EA Engineering, Science,  
and Technology, Inc.

RE: Expansion of LOOW Phase II RI (Response to Phase II RI Letter 03)

SUBJECT: Phase II RI Letter 03

Reference is made to Delivery Order 0115, Lake Ontario Ordnance Works (LOOW) Site Wide Remedial Investigation Phase 2 under your contract DACA31-94-D-0015.

FIGURE 1 MAP OF FORMER LOOW COMPONENT 2 SITE

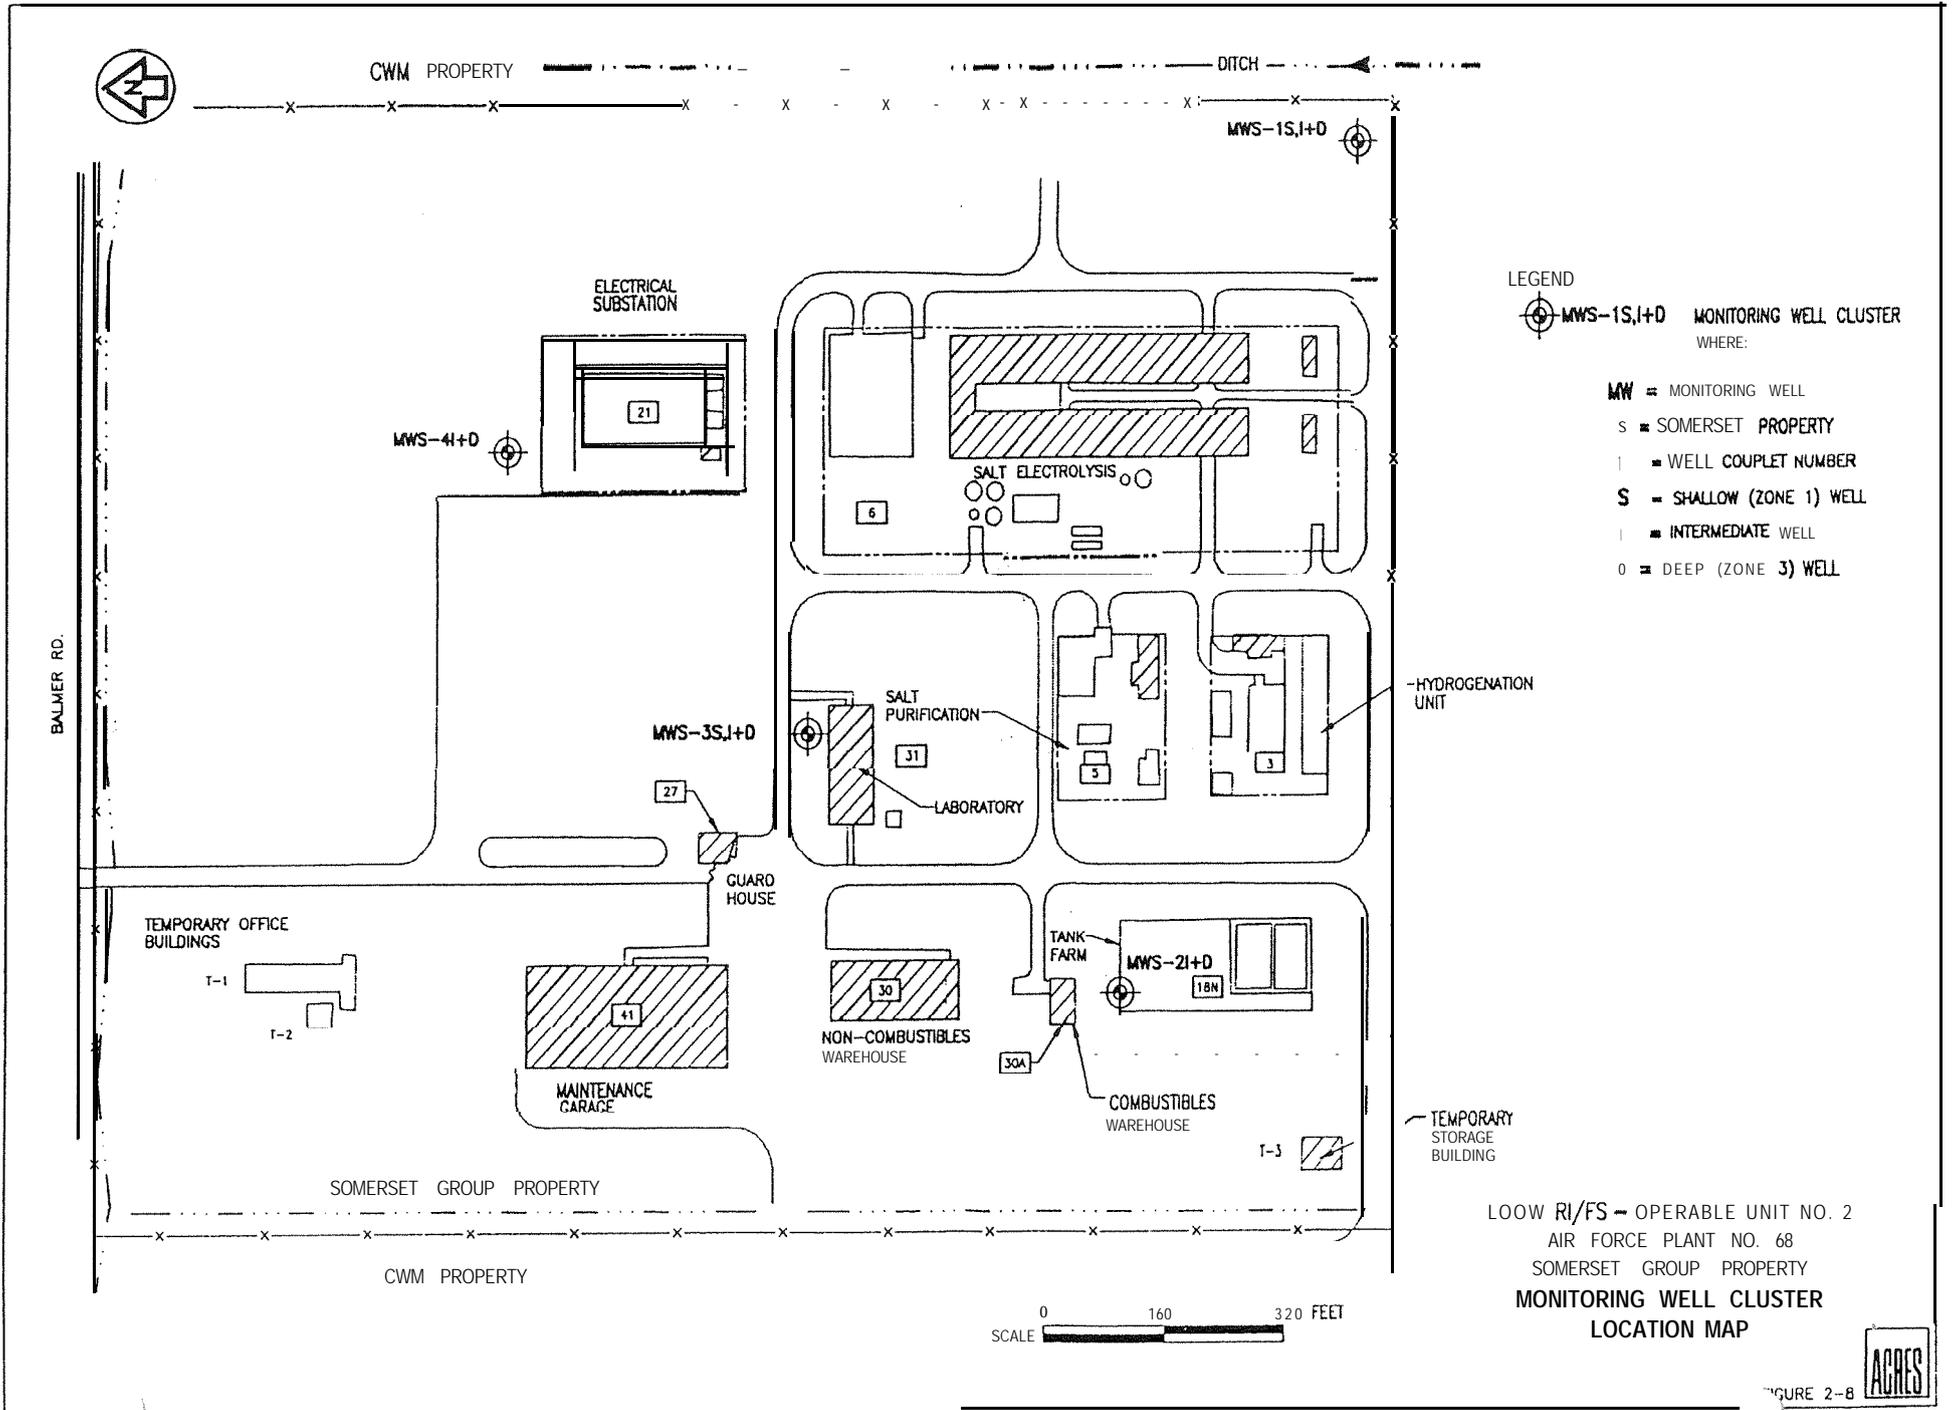
Because sampling of existing wells Component 2 was not included in the original Phase II investigation, a SAP does not currently exist. By owner request and approval by USACE, ground water sampling of Component 2 existing wells has being added to Phase II RI. The investigation shall include the following:

According to the Preliminary Contaminant Assessment Report (Acres 1992), there are ten existing wells at Component 2, Somerset Property(see Figure 1).

MWS-41 and D  
MWS-3S, I and D  
MWS-21 and D  
MWS-1S, I and D

Where S, I, and D represent shallow, intermediate, and deep screening intervals, respectively. A reconnaissance of existing wells at Component 2 will be performed to determine the condition of the well. The wells will be checked for breaks and blockages in the well casing, evidence of frost heaving, lock integrity and PVC riser integrity. In addition, the depth to the bottom of the well, and to the water table will be measured and recorded. Attached are two tables, from ACRES Preliminary Contamination Assessment Report (1992), which provide information from well installation and water level measurements, respectively (see Table B-15-1 and Table B-15-2).

Assuming water is present, wells deemed secure and intact based on the visual survey described above will be redeveloped. Development will be performed according to the SOP established for Phase II RI.

A ground-water sample will be collected from each well in accordance with the SOPs established in the Phase II RI. The sampling strategy can be found in Table B-15-3. The samples will be sent to STL Laboratories for analysis of full suite parameters as listed in Table B-15-4.

The locations of the existing monitoring wells will be surveyed in reference to the NY State Plane Coordinate System with an accuracy of +/- 3 ft. The elevation of the PVC stick-up reference will be surveyed in reference to Mean Sea Level with an accuracy of +/- 0.05 ft.
